## **ALVERSON COMMERCIAL PARK SUBDIVISION,** **RESUBDIVISION OF LOT 1**

APPLICATION NUMBER 9 DATE September 5, 2013  
APPLICANT Alverson Commercial Park Subdivision, Resubdivision of Lot 1  
REQUEST Subdivision

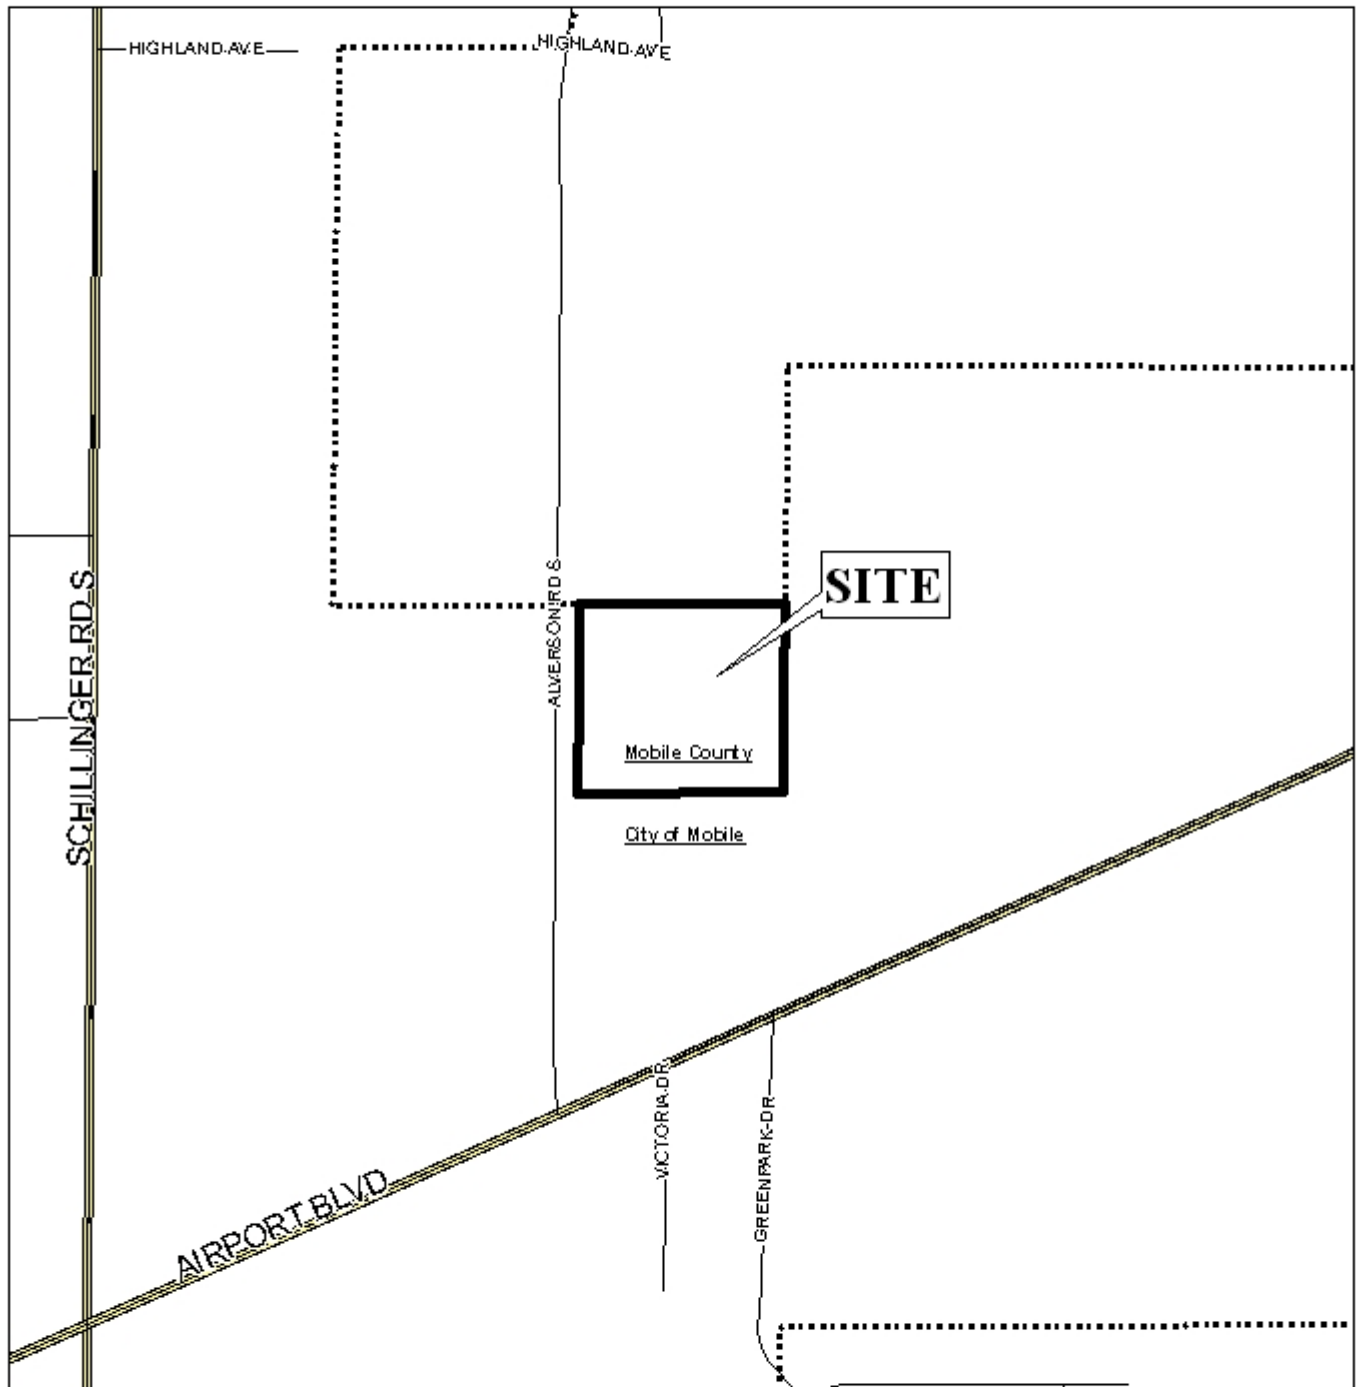
The preliminary plat illustrates the proposed 2-lot, 3.9 ± acre subdivision which is located on the East side of Alverson Road South, 585' ± North of Airport Boulevard. The site is within the Planning Jurisdiction and the applicant states that the subdivision is served by both public water and sewer.

The intent of this application is to subdivide an existing legal lot, which was approved by the Planning Commission in 2005 as a 1-lot subdivision, into two lots. In accordance with the Subdivision Regulations, both proposed lots are compliant with the minimum size requirements. The 25-foot minimum building setback line and the lot sizes in square feet are illustrated on the preliminary plat and should be retained on the Final Plat if approved.

Both proposed lots have frontage along Alverson Road South, a minor street, which does not have curb and gutter. The existing right-of-way width of 60' is compliant with Section V.B.14. of the Subdivision Regulations and no dedication is required.

The proposed Lots 1 and 2 have one existing curb-cut each along Alverson Road South. As a means of access management, a note should be placed on the Final Plat limiting both lots to the existing curb-cuts, with any changes to be approved by Mobile County Engineering and conform to AASHTO standards.

- 1) Retention of the lot size information and the 25-foot minimum building setback line on the Final Plat;
- 2) Placement of a note on the Final Plat limiting both lots to the existing curb-cuts, with any changes to be approved by Mobile County Engineering and conform to AASHTO standards;
